Special Use Permit #2024-00041
404-A East Alexandria Avenue

Application	General Data	
Public Hearing and consideration of requests for Special Use Permits to construct a single-unit dwelling on a vacant substandard lot and for a lot without frontage on a public street	Planning Commission Hearing:	November 7, 2024
	City Council Hearing:	November 16, 2024
Address: 404-A East Alexandria Avenue	Zone:	R-2-5/ Residential
Applicant: Eric Teran and Daniela Gross	Small Area Plan:	Potomac West

Staff Recommendation: APPROVAL subject to compliance with all applicable codes, ordinances, and the recommended permit conditions found in Section III of this report.

Figure 3 - North Elevation (Front)

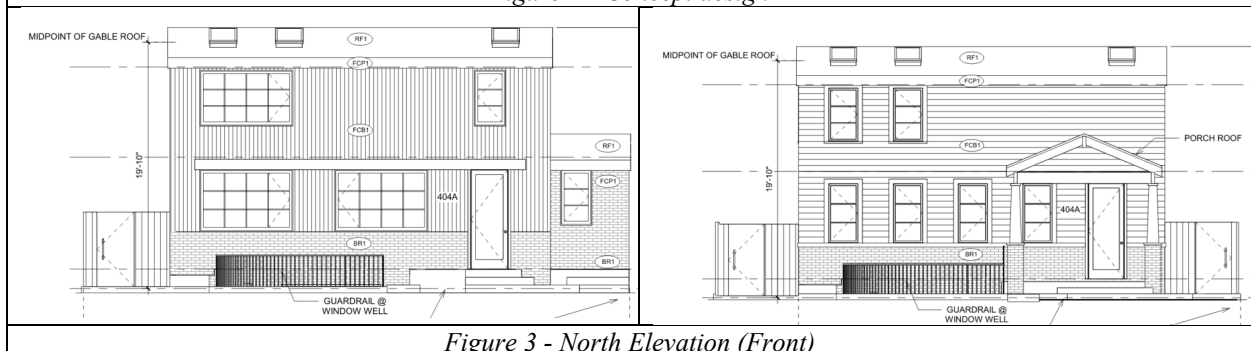
The applicants’ have changed the previous contemporary architectural style. The new design would have a predominately Colonial Revival style with a small front porch, a low-pitched side facing gable, symmetrical window placement, and rectangular massing. The front porch would also incorporate Craftsman style tapered porch columns. The windows would have a contemporary feel with three divided lites. Figures two through five, below, show the proposed elevations as they compare to the previous application. The applicant has removed the accessory dwelling unit from their proposal.

- c. **MARGINAL DIFFERENCE: With the exception of the changes in the size of windows in figure 4 of the staff report, there is NO CHANGE in symmetry of the window positioning.** Furthermore, it is confusing as to why staff chose to highlight symmetry as the defining “change” when the applicants simply described their adjustment as “windows resized” with no mention of consideration of symmetry of window placement (pg. 50-51 of new applicant materials, also labeled as pg. 87-88 of the current staff report).

- The 4-quadrant elevations referenced (figures 3-6, incorrectly referenced in the writeup above as figures 2-5) show drawings comparing the previous vs. new application designs; **all have the same dimensions for the proposed dwelling - THERE IS NO DIFFERENCE.**

Figure 7 - Site Plan

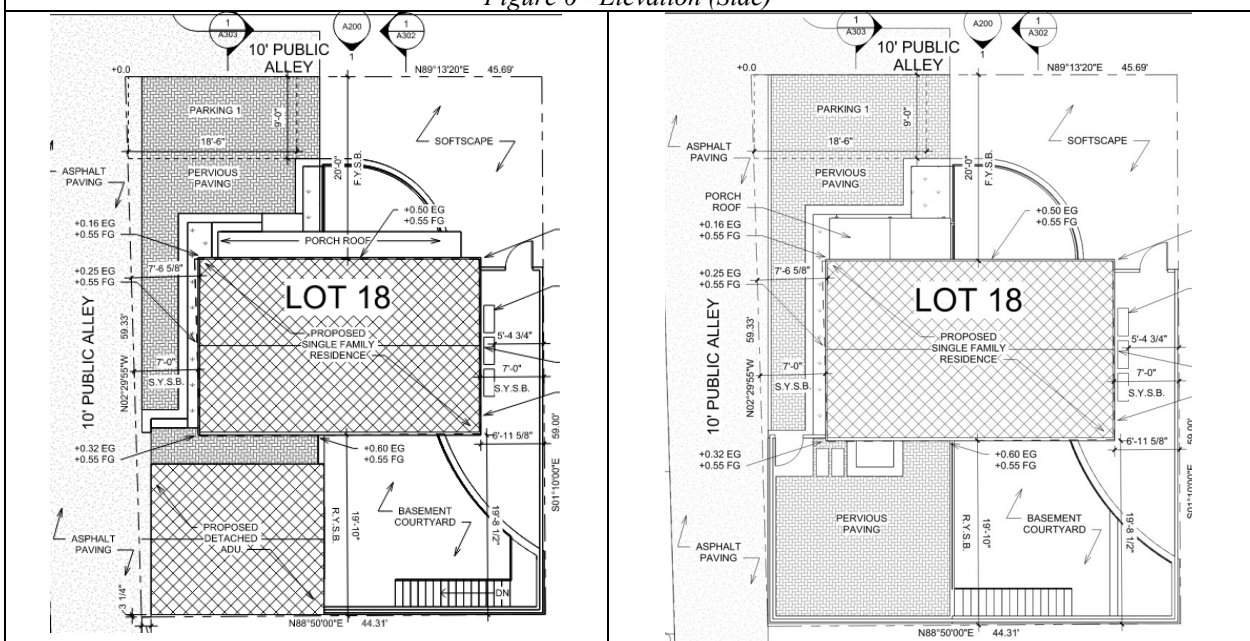
The dwelling would measure approximately 30.67 feet by 19.17 feet with a footprint of about 655 square feet, including the front porch which has been reduced in length and expanded in depth. It would provide a front yard of 20 feet; a west side yard of 7.0 feet; an east side yard of 7.0 feet; and an increased rear yard setback from zero feet to 19.83 feet with the removal of the ADU. Figure 7, below, shows the previous and current proposed site plan.

The dwelling would measure approximately 30.67 feet by 19.17 feet with a footprint of about 655 square feet, including the front porch which has been reduced in length and expanded in depth. It would provide a front yard of 20 feet; a west side yard of 7.0 feet; an east side yard of 7.0 feet; and an increased rear yard setback from zero feet to 19.83 feet with the removal of the ADU. Figure 7, below, shows the previous and current proposed site plan.

SITE PLAN

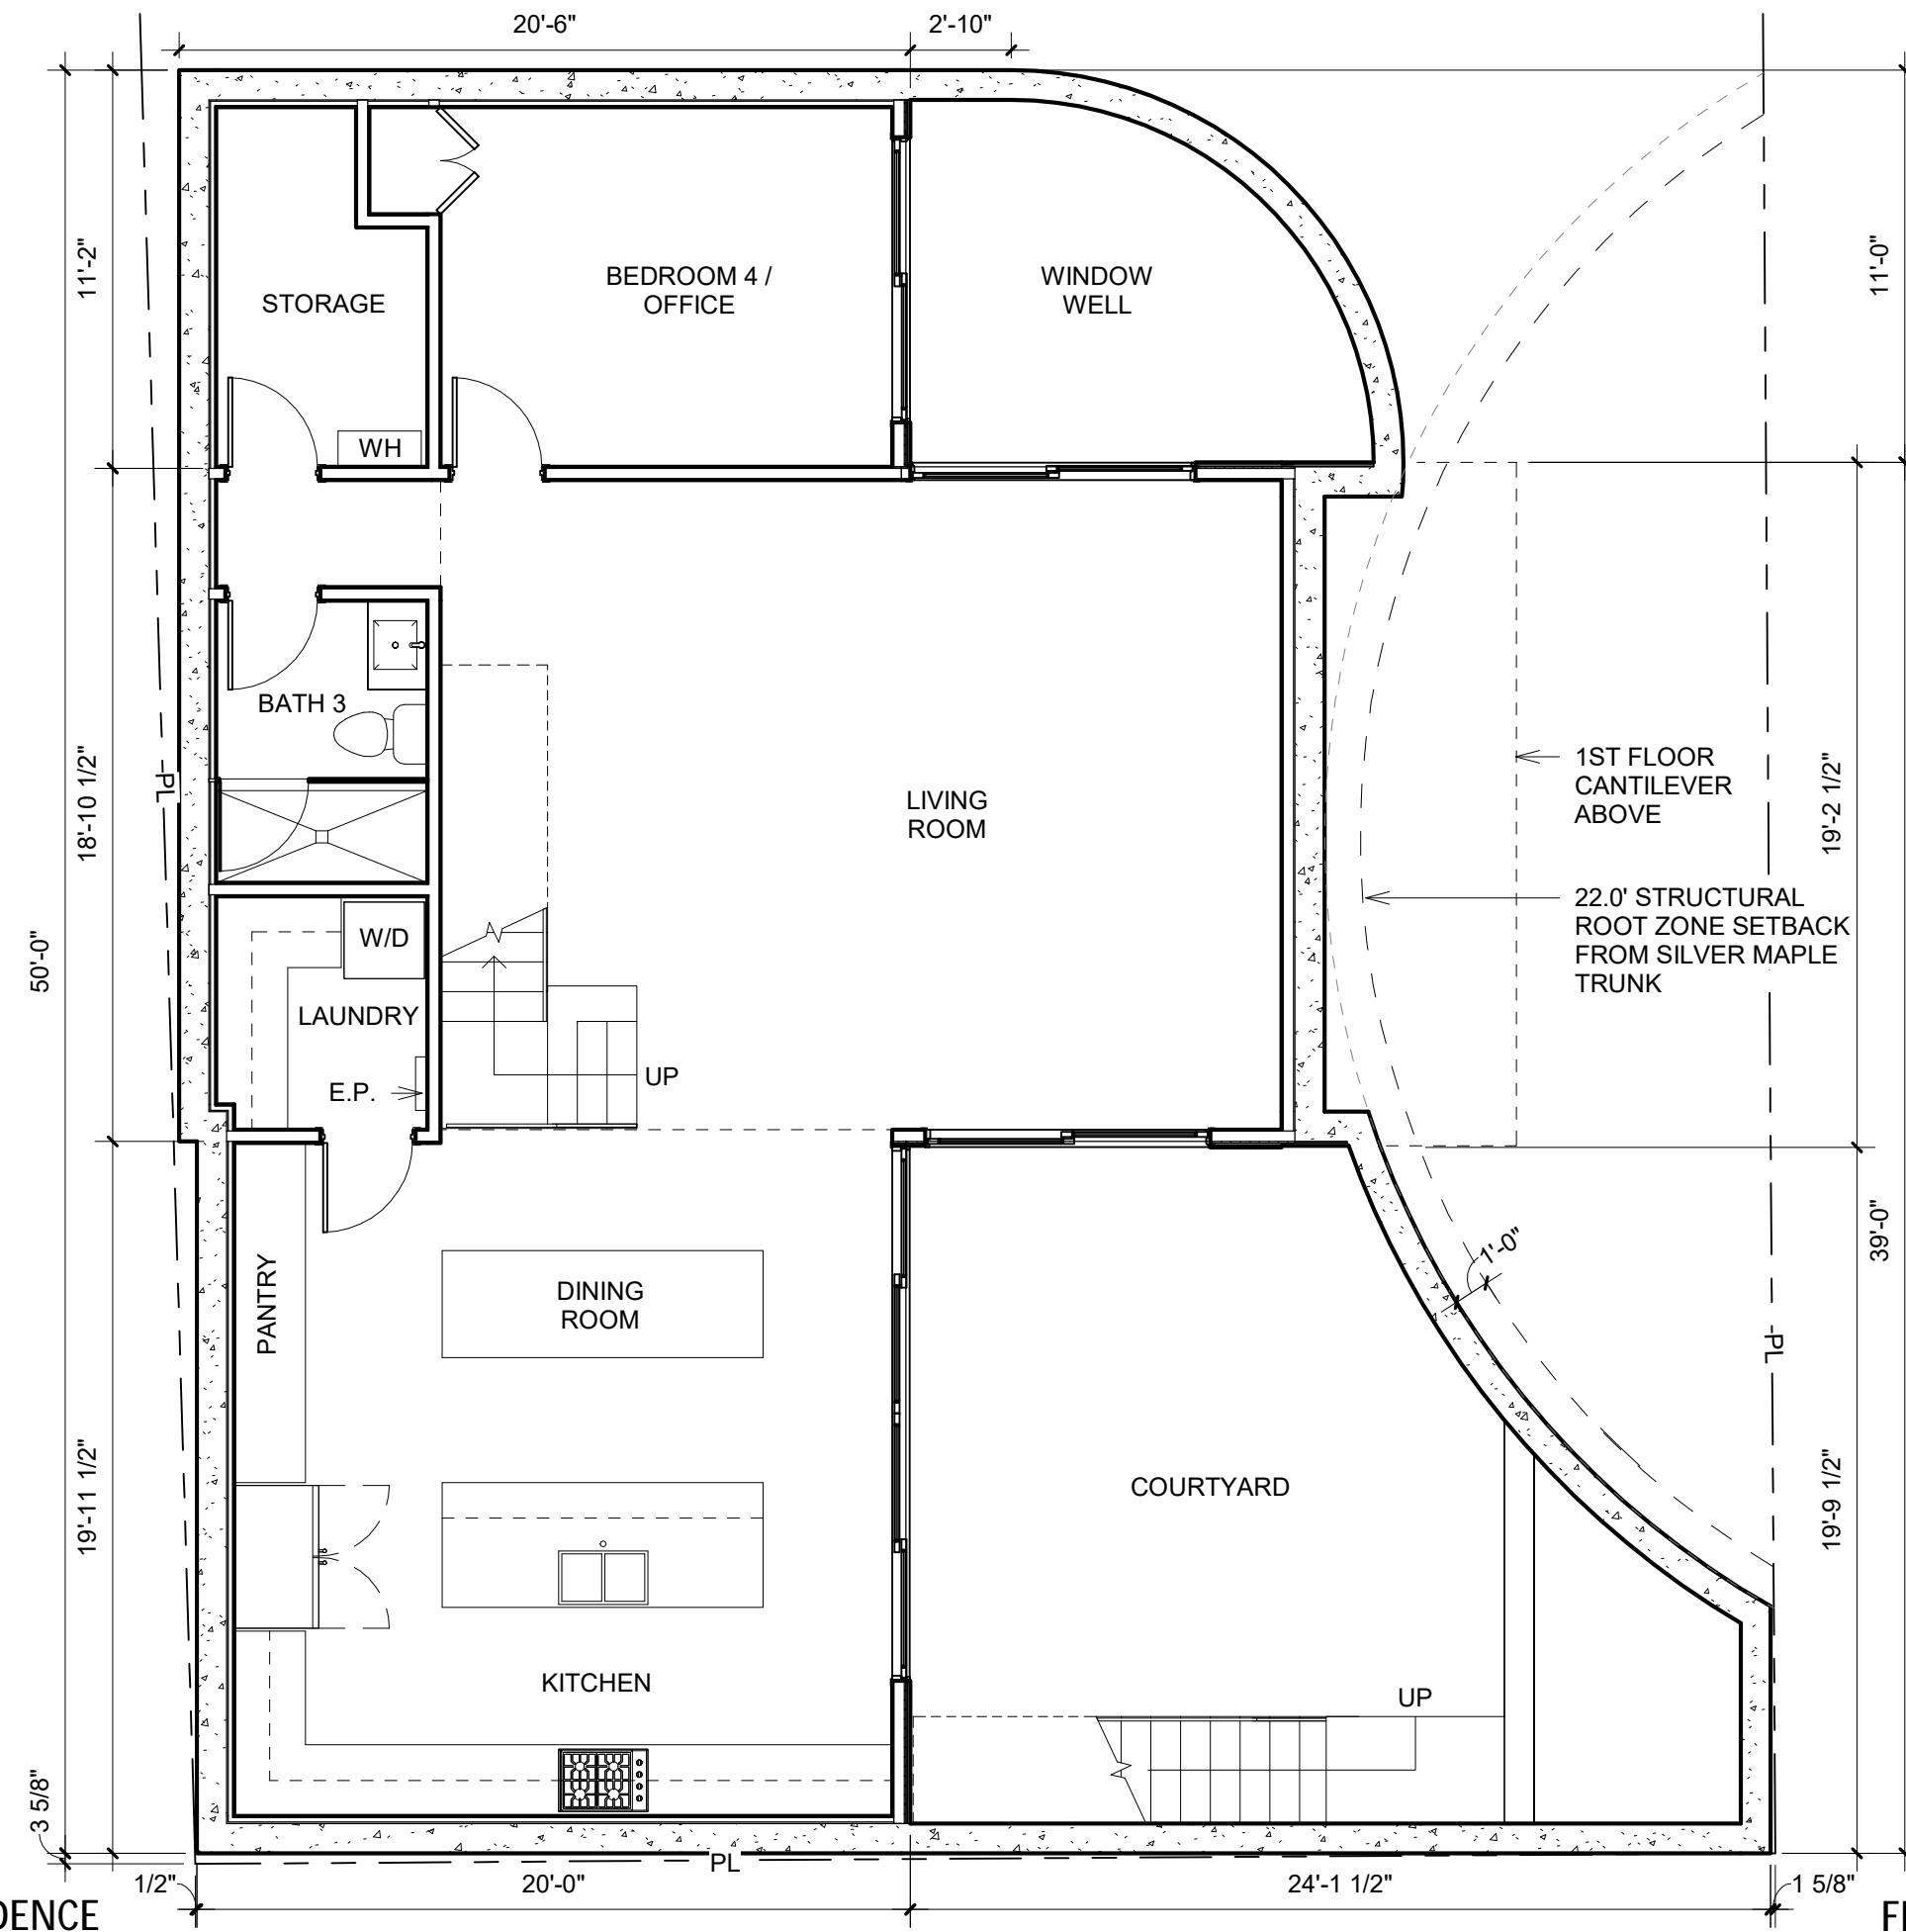
- Finding: Condenser units will need a waiver.
- Fence cannot be more than 6 feet.
- On the project information page 13, match the FAR numbers with the FAR worksheet.
- On the material compatibility page 41, it says the orientation is east to west like the homes on Mount Vernon Avenue - this is not correct. The house is oriented the same as the dwellings on E Nelson.
- Clarify why the first floor is less square footage than the second floor
